MINOR AMENDMENT OF  
MDP/P.U.D. PLAN

NORTH POINTE SUBDIVISION

Re: North Pointe(Amended)

**MDP # 813-A**

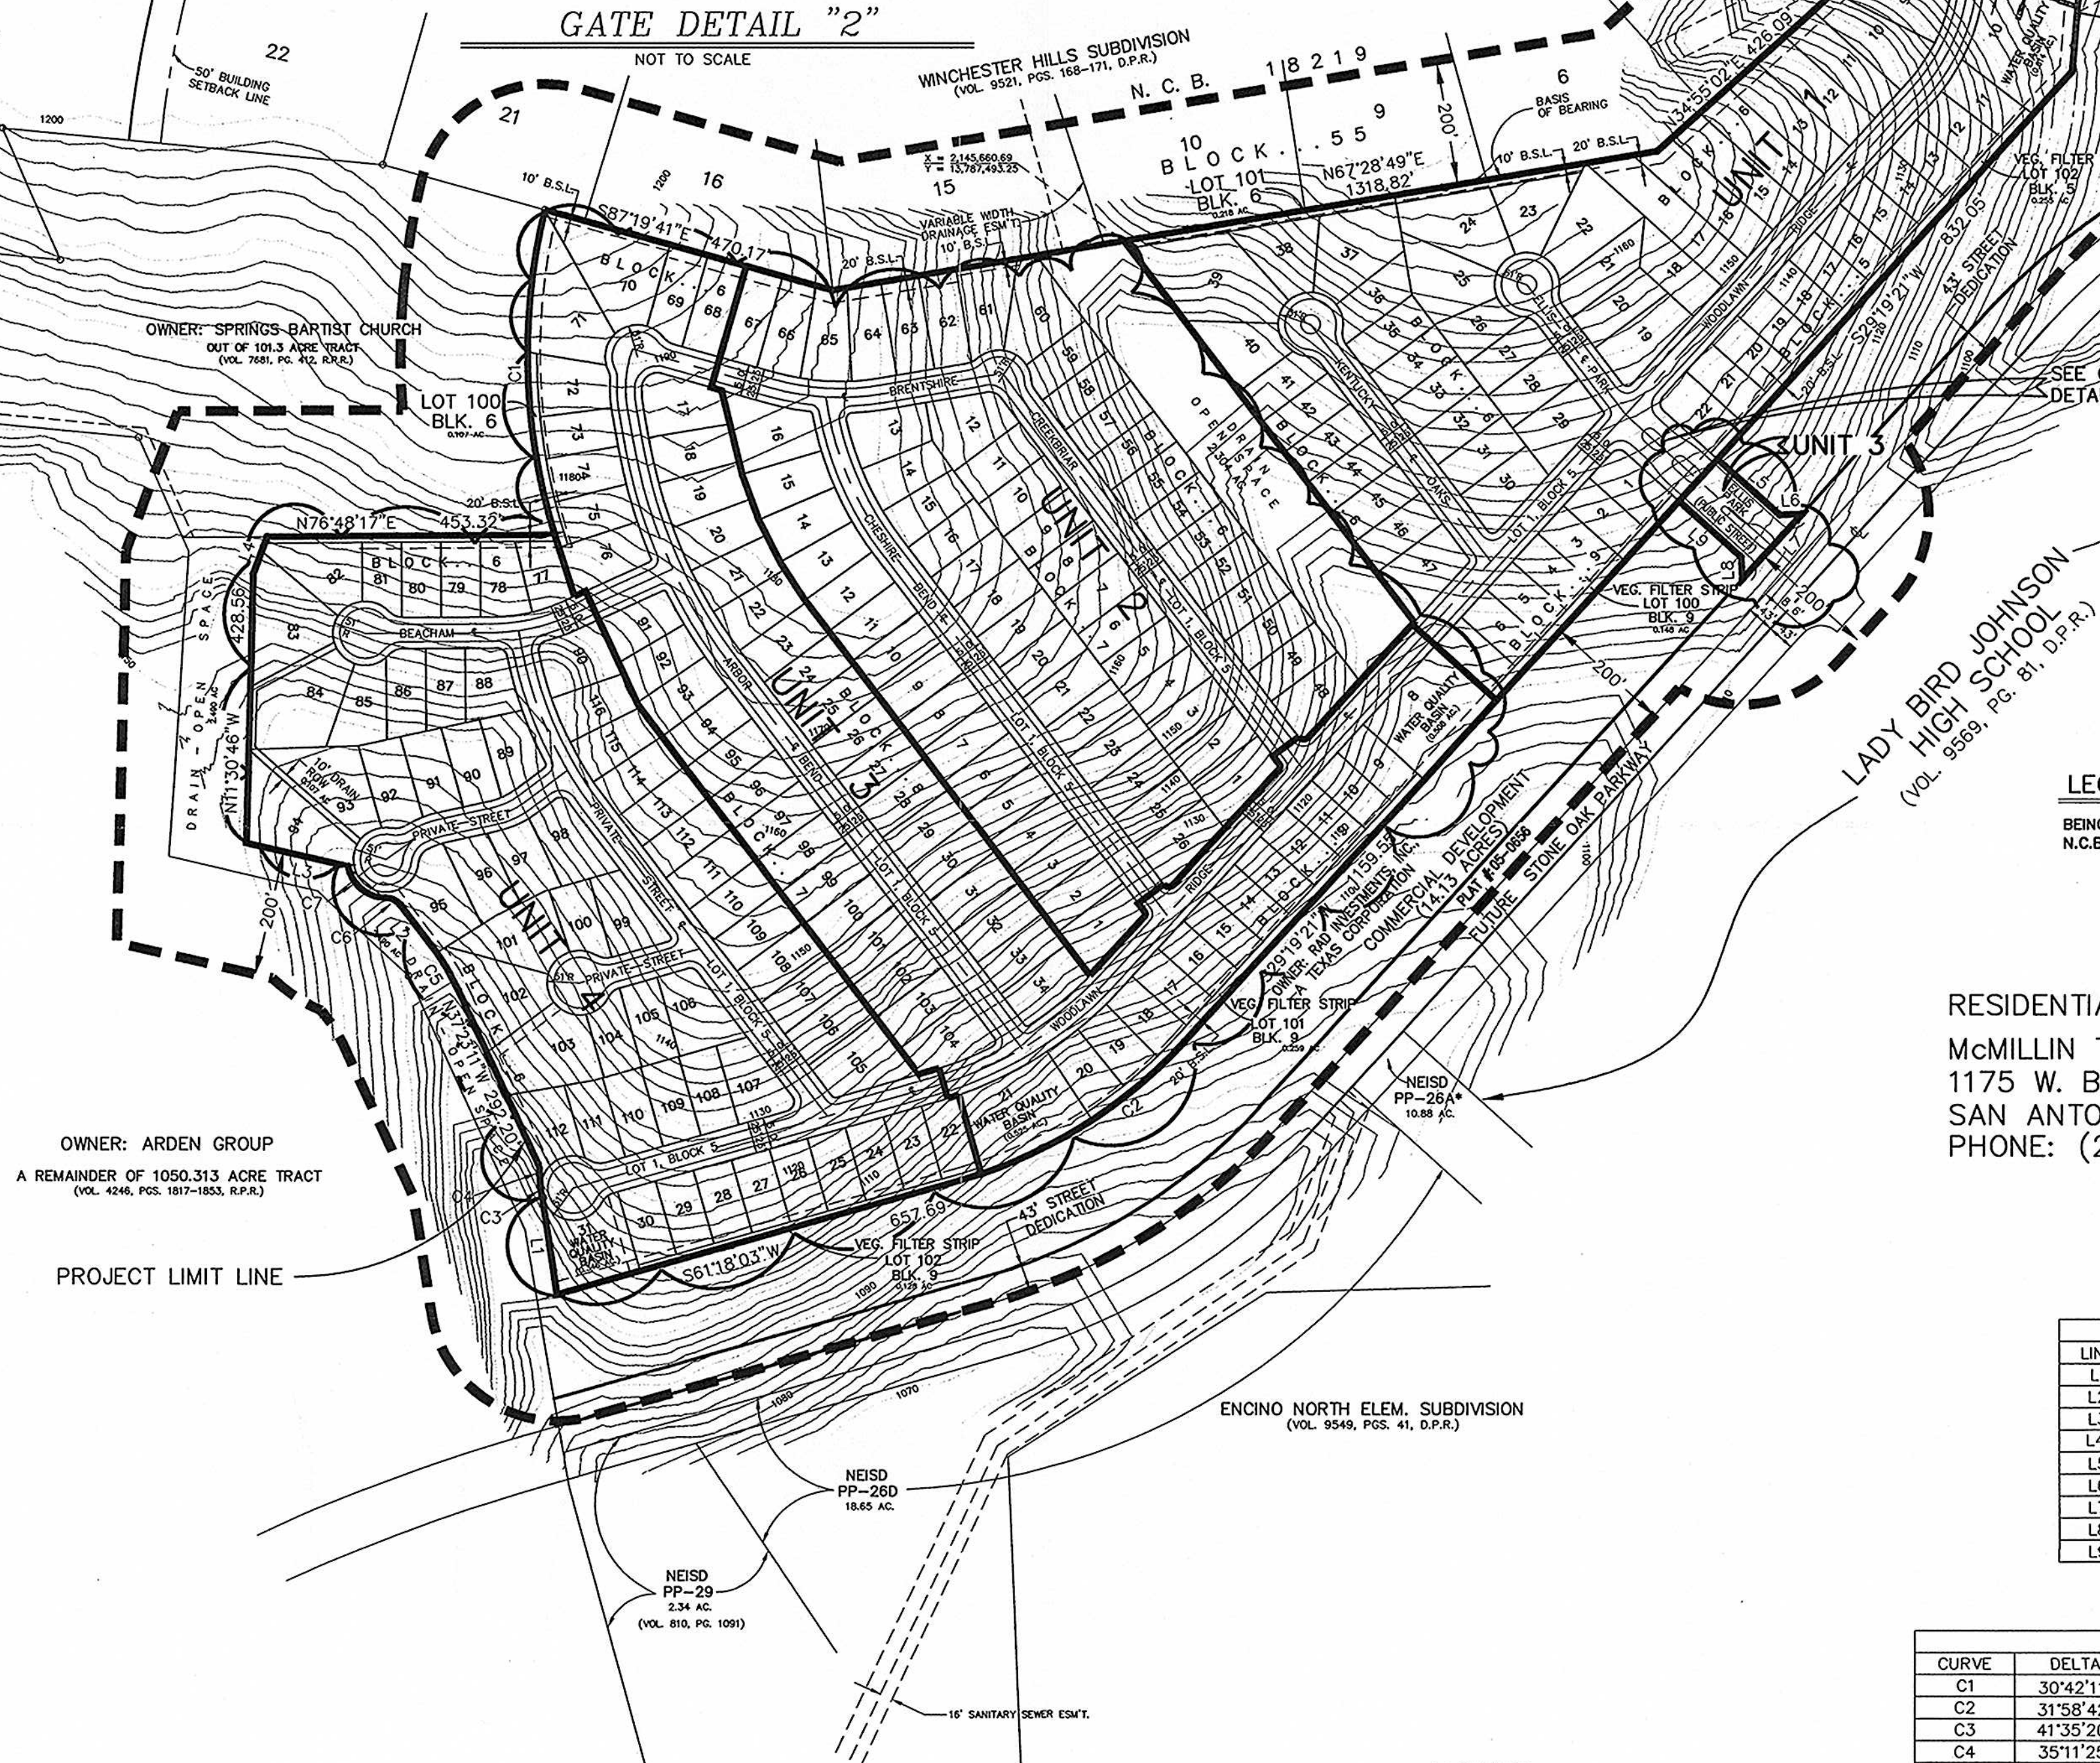
The City Staff Development Review Committee has reviewed North Pointe Master Development Plan **M.D.P. # 813-A**. Please find enclosed a signed copy for your files. Your plan was approved for acceptance; however please note the following conditions:

In consideration of public safety and convenience, excessive grades by reason of topography should be avoided in street layouts and arrangements. Any access and R.O.W. issues along state facilities will need to be resolved with the **Texas Department of Transportation (TXDOT)**. For information about these requirements you can contact TXDOT at 615-5814.

**DSD – Traffic Impact Analysis & Streets** states: It shall be understood that the submitted MDP Plan is a conceptual plan and therefore this document does not represent an approval for the internal street plan. All streets shall follow UDC 35-506 and the street network shall be planned in order to provide safe and efficient movement of traffic to and from, within and past, the proposed development, while minimizing the impact to non-site trips. UDC 35-506 will be implemented at the time of platting.

- Given the known hydraulic conditions of this watershed at this time, this development is eligible for FILO. Should the dynamics of the watershed change that show "adverse impact" then a reconsideration to provide detention will be considered.
